1427 HARO STREET (COMPLETE APPLICATION)
DE418712 - ZONE RM-5B

DEVELOPMENT PERMIT STAFF COMMITTEE MEMBERS

DEVELOPMENT PERMIT STAFF COMMITTEE RECOMMENDATION: APPROVE

SITE PLAN	
Date	2014 DEC 23
Project Number	1239
Scale	As Indicated
Quantity	CK
Approval	CK
DP100

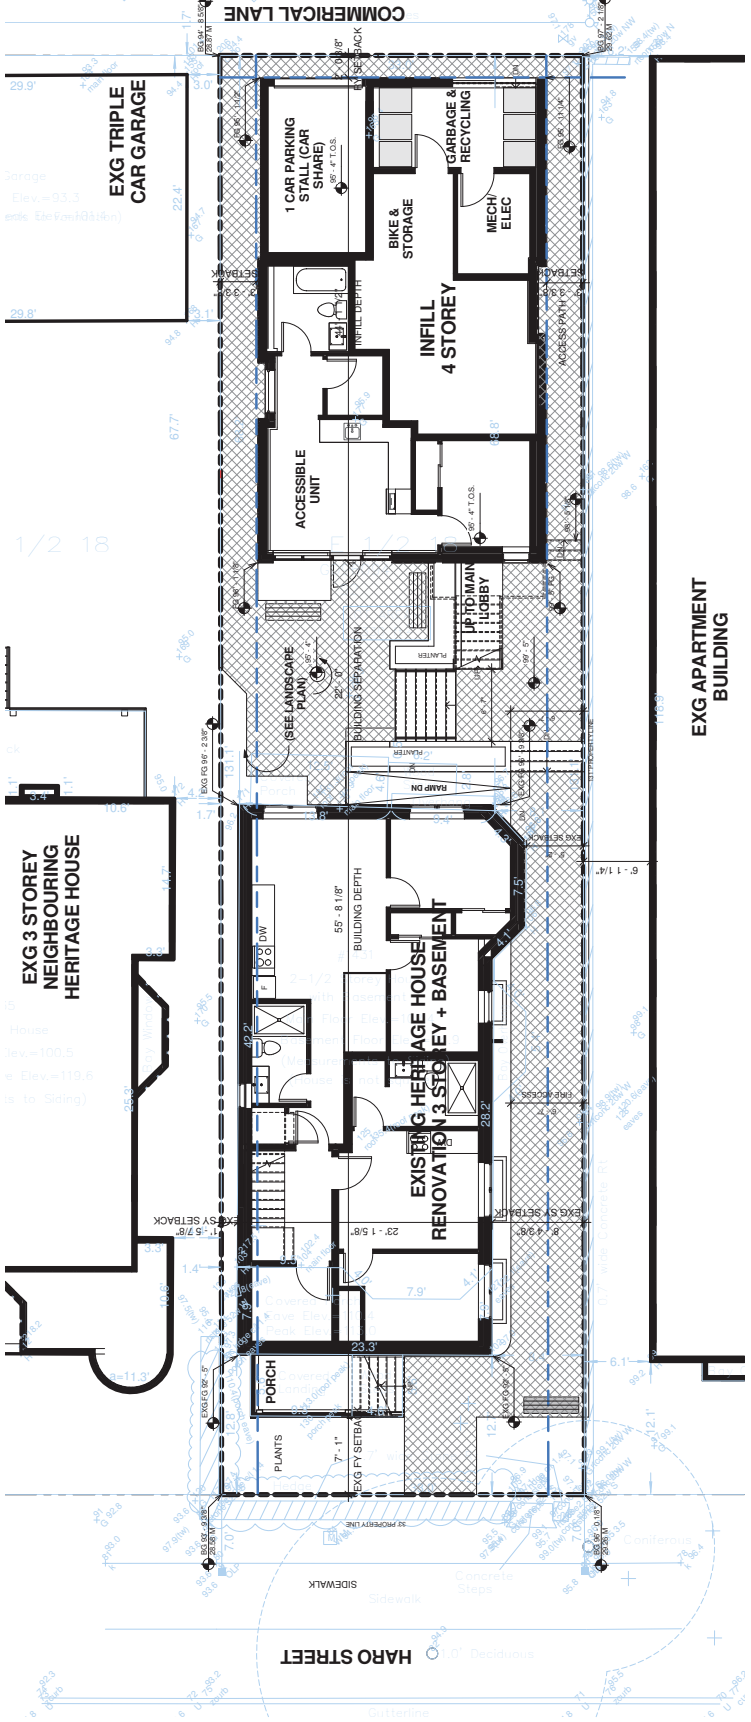
A.1.12 city building grades, existing and finished grades to be shown on the site plan including around the perimeter of all principal and accessory buildings;

- A.1.28 coordination of landscape plan, site plan and survey with the arborist report by the addition of the two existing site trees on the plans;
-

Note to Applicant: The arborist report calls Tree #1 and #2 to be permit sized. These trees should be added to the survey with corrected sizes, the site plan and landscape plan (suggest dashed line), noted to be removed.

② 1-4 INFILL ROOF
1/4" = 1'-0"

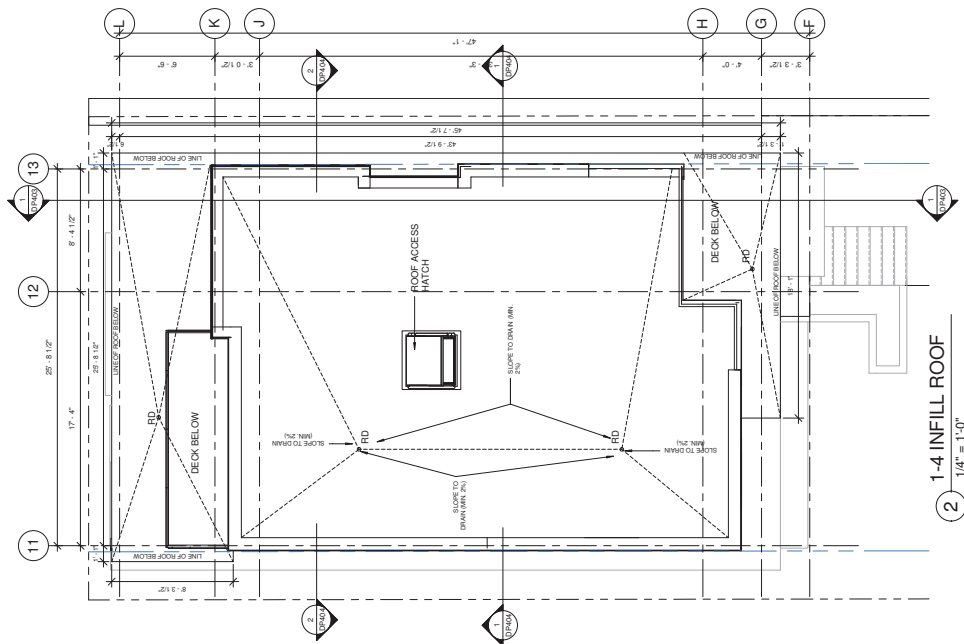
- 1.1 design development to provide improved outdoor amenity space for the family units, Units 301 and 302, in the new infill building by providing access to the roof deck;

Note to Applicant: The roof deck should incorporate an intensive green roof consistent with the expectations of the Administrative Bulletin: 'Roof-Mounted Energy Technologies and Green Roofs - Discretionary Height Increases' and appropriate for families with children.

① 1-4 WEST ELEVATION
1/4" = 1'-0"

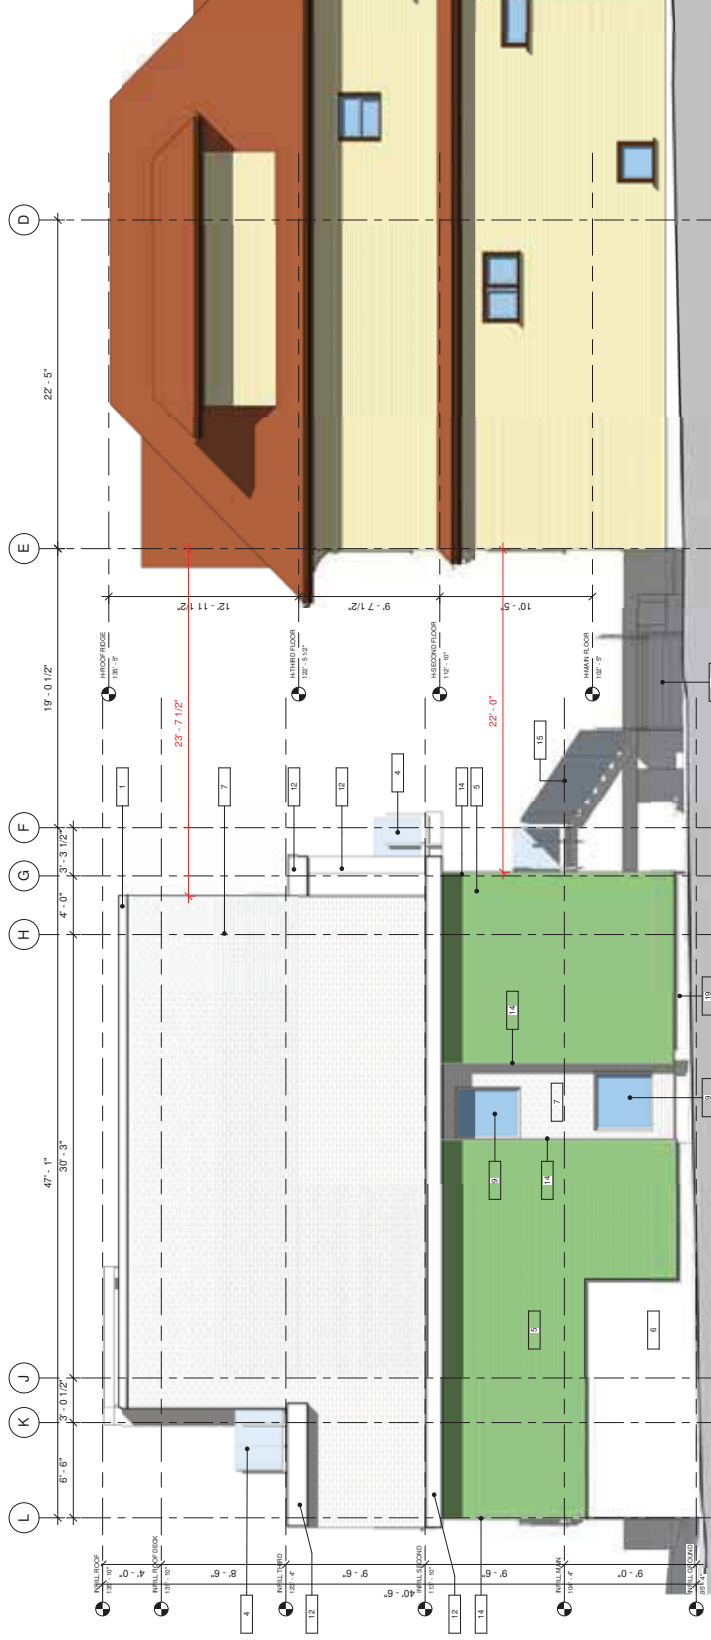
- A.1.2 design development to provide improved visual interest at the side elevations;

Note to Applicant: Provide more varied material treatment, including shallow changes in plane, where possible to further articulate the west side elevation. A 'green wall' or trellis with planting may be provided at the east side to soften the visual impact on the adjacent building.
